Technical Service Bulletin: TSB110116

QSK78 New Generation Flexplate

This document announces the release of a new generation flexplate for use in QSK78 diesel engines.

Old and New Generation Flexplates

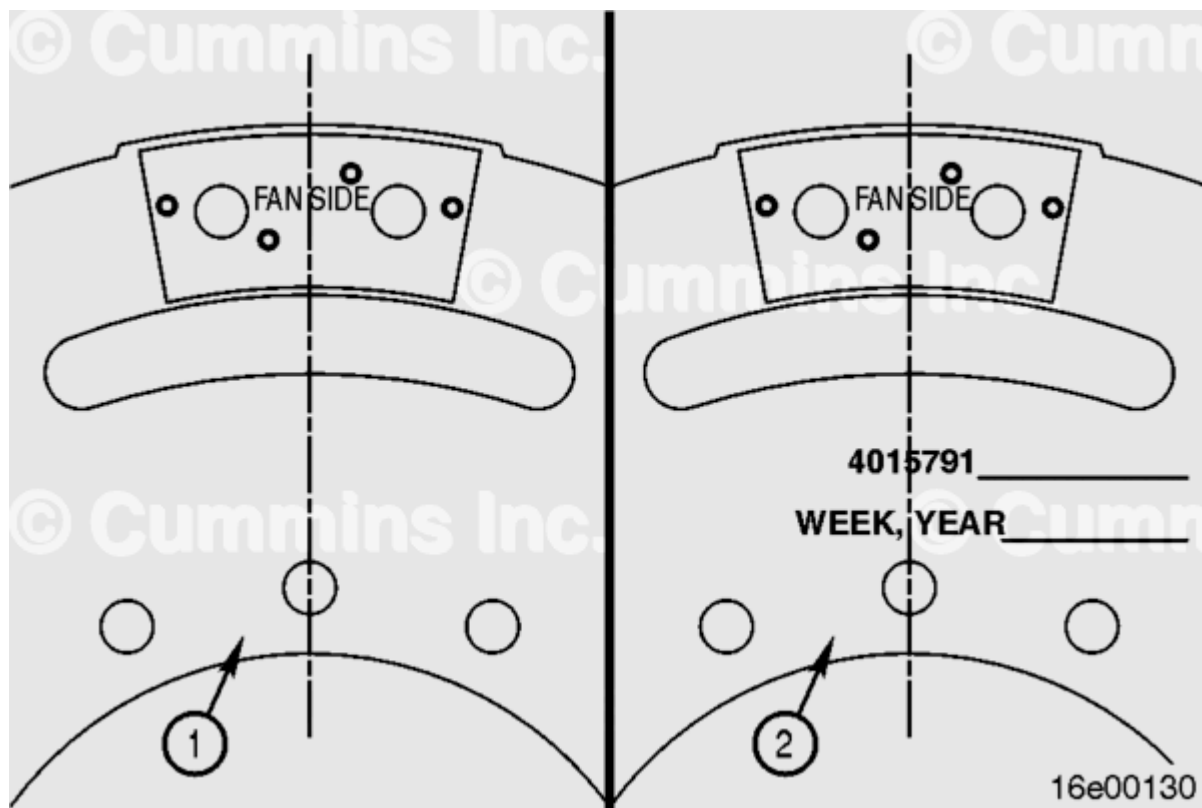
The part number has **not** been changed. The new generation flexplate, Part Number 4015791, supersedes the previous generation flexplate. The new flexplate has an improved material characteristic for better reliability.

1. Old Generation Flexplate - The **only** marking indicating "FAN SIDE" is stamped or etched close to the outer edge of the flexplate. There are no markings indicating part number and week/year of production.
2. New Generation Flexplate - The part number and production week/year are etched centrally under the stamped or etched marking indicating "FAN SIDE" which is located close to the outer edge of the flexplate.

Note : A correctly installed flexplate will have the "FAN SIDE" marking facing outward from the engine block, towards the generator fan.
